3/4.2 POWER DISTRIBUTION LIMITS

3/4.2.1 AVERAGE PLANAR LINEAR HEAT GENERATION RATE

**FLOW DEPENDENT MCPR OPERATING LIMIT
FIGURE 3.2.3-1**

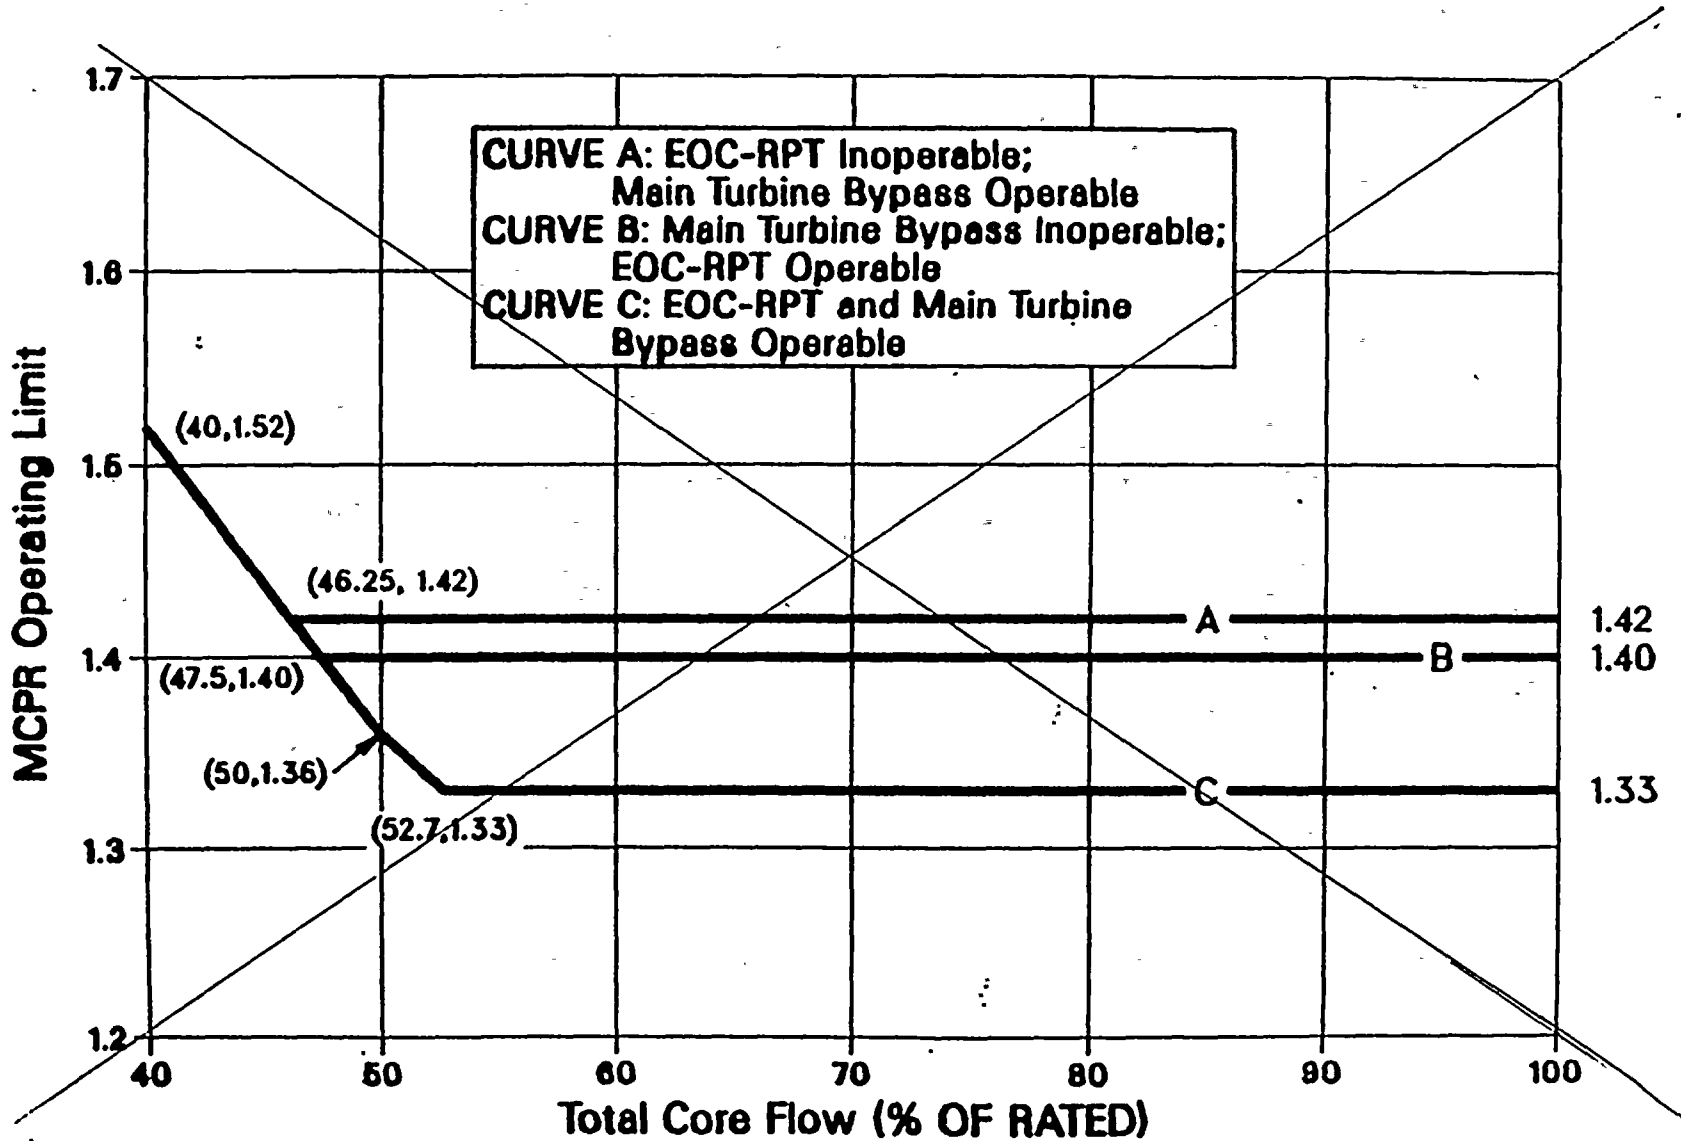
3.2.1 All AVERAGE PLANAR LINEAR HEAT GENERATION RATES (APLHGRs) for each type of fuel ~~as a function of AVERAGE BUNDLE EXPOSURE for ANF fuel~~ shall not exceed the limits shown in Figures 3.2.1-1 and 3.2.1-2.

4.2.1 All APLHGRs shall be verified to be equal to or less than the limits determined from Figures 3.2.1-1, and 3.2.1-2.

~~*See Specification 3.4.1.1.2.a for single loop operation requirements.~~

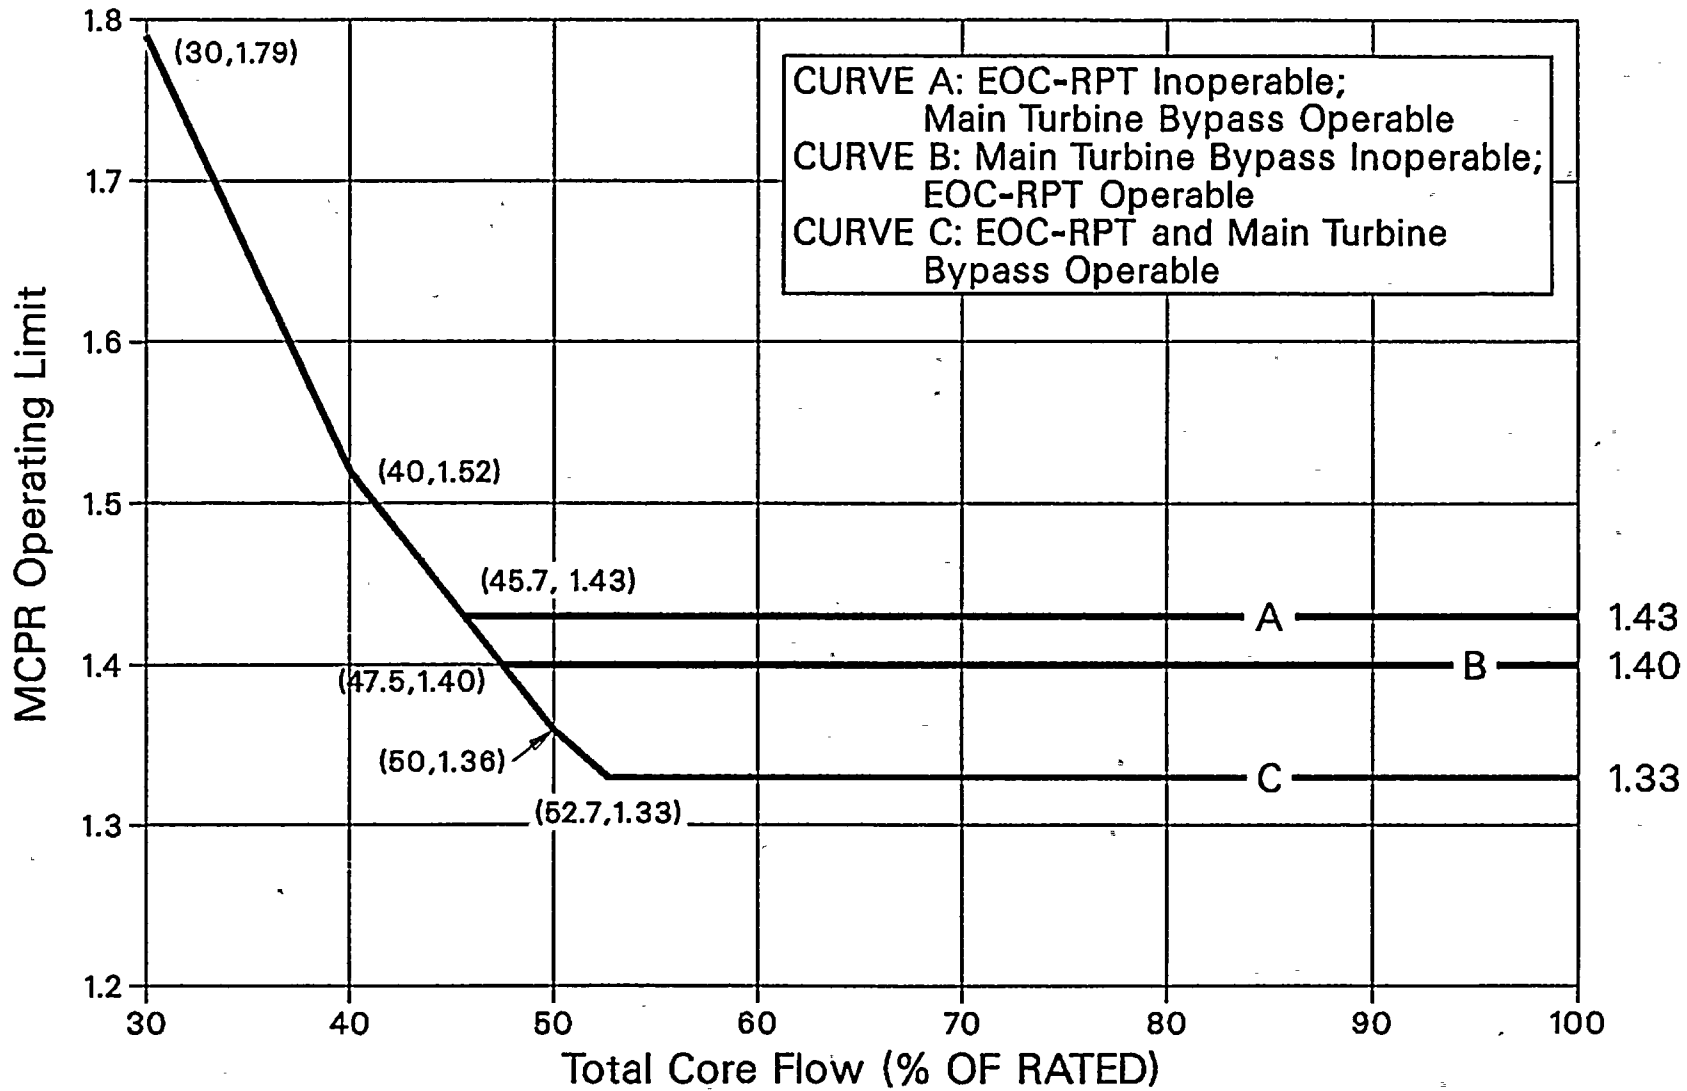
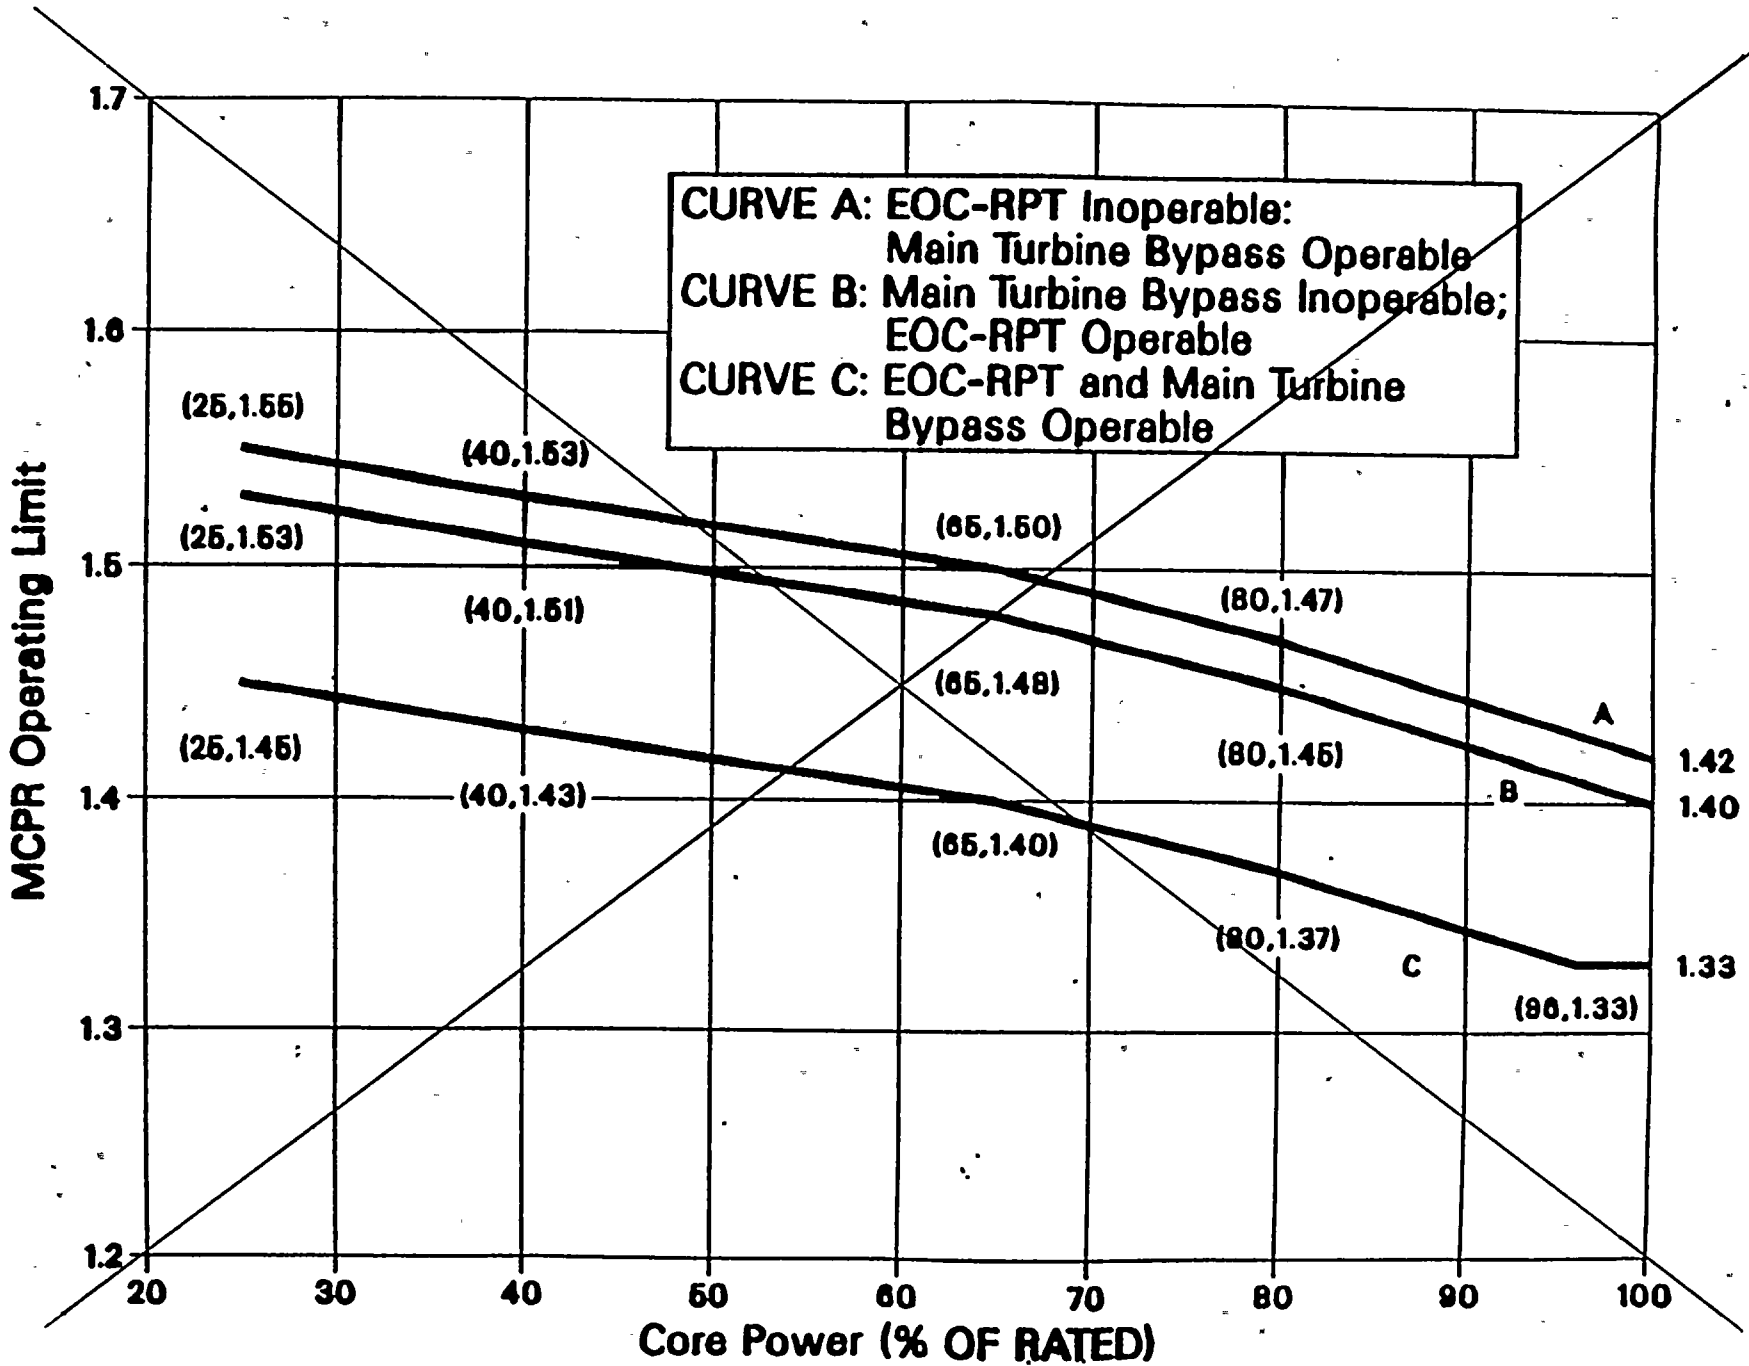
REPLACE WITH NEW FIGURE 3.2.3-1, ATTACHED

CURVE A: EOC-RPT Inoperable;
Main Turbine Bypass Operable
CURVE B: Main Turbine Bypass Inoperable;
EOC-RPT Operable
CURVE C: EOC-RPT and Main Turbine
Bypass Operable

REDUCED POWER M CPR OPERATING LIMIT
Figure 3.2.3-2

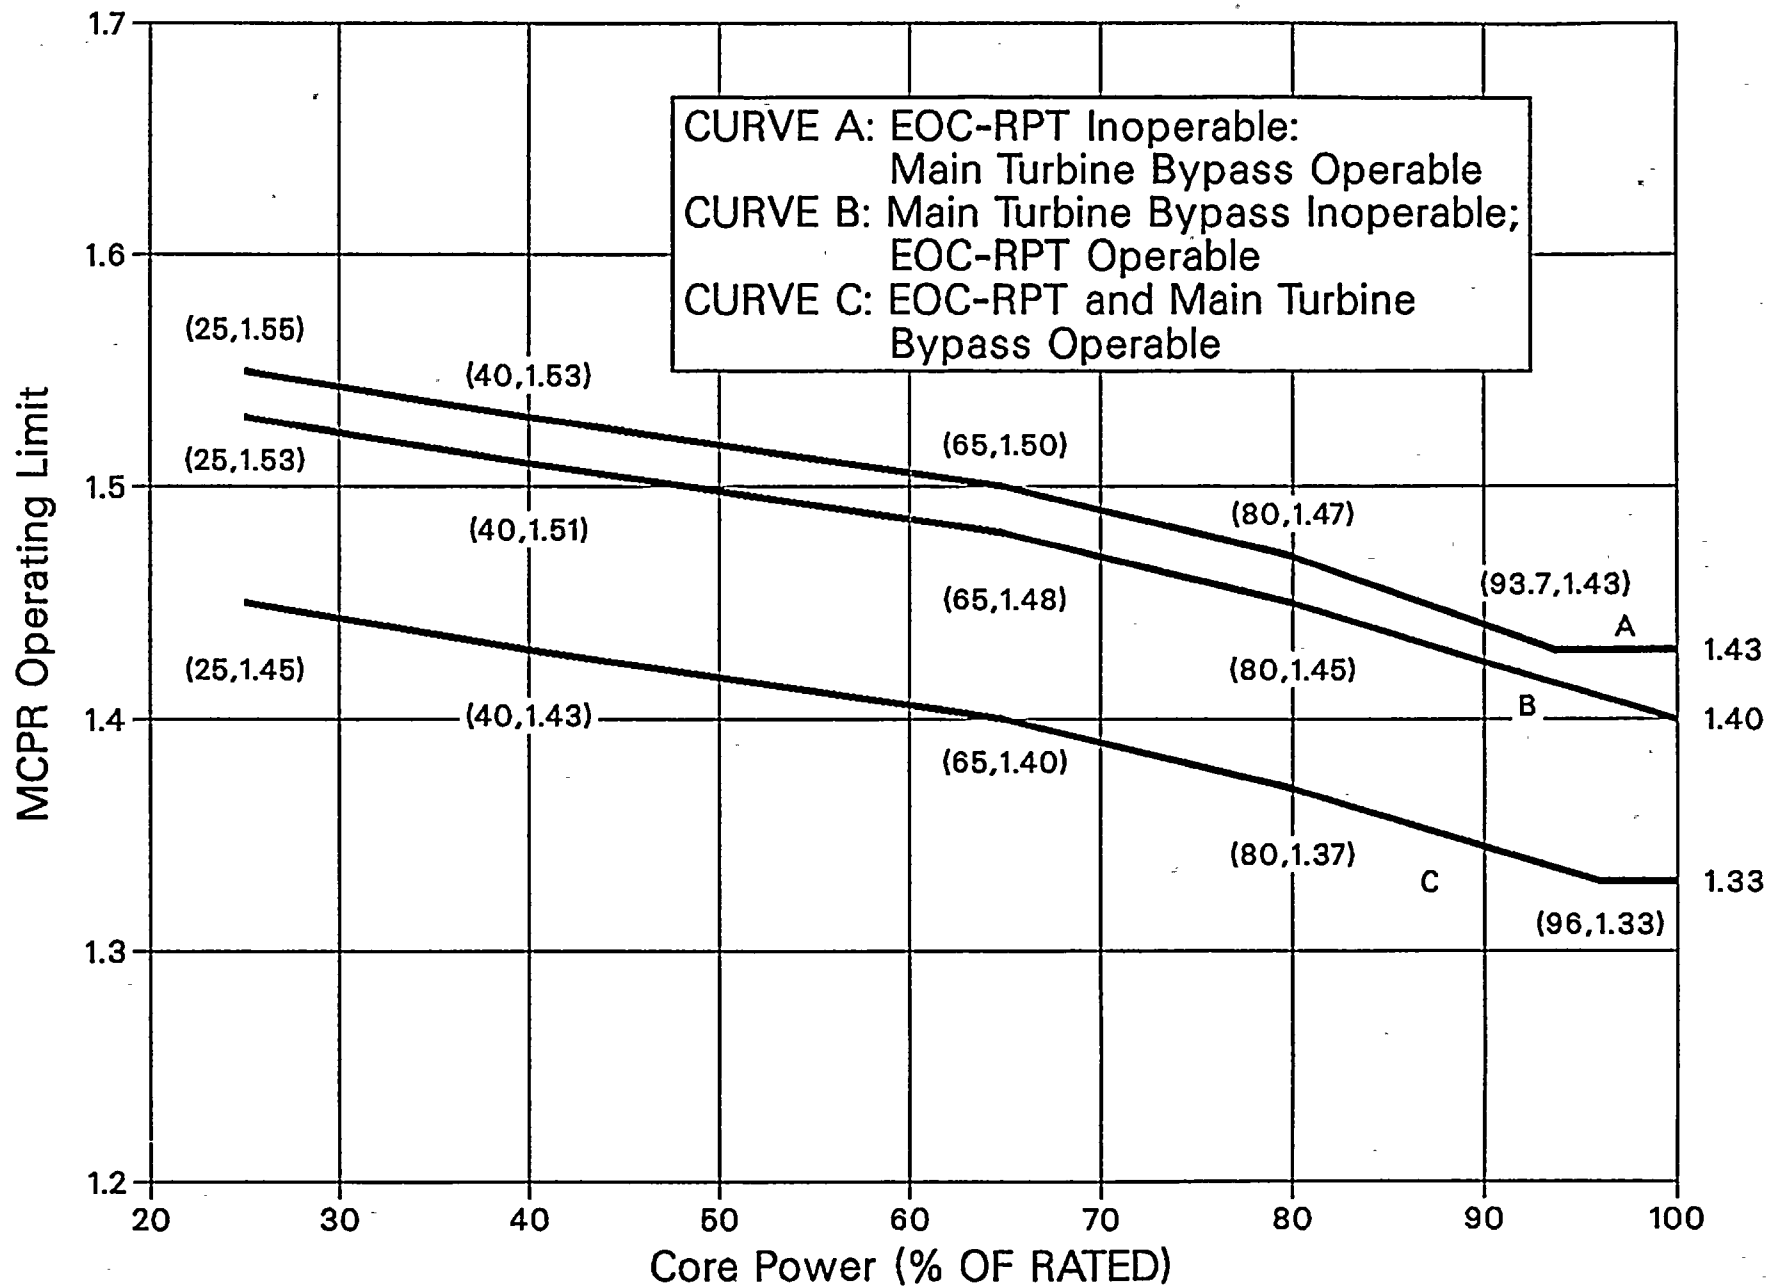
REPLACE WITH NEW FIGURE, ATTACHED
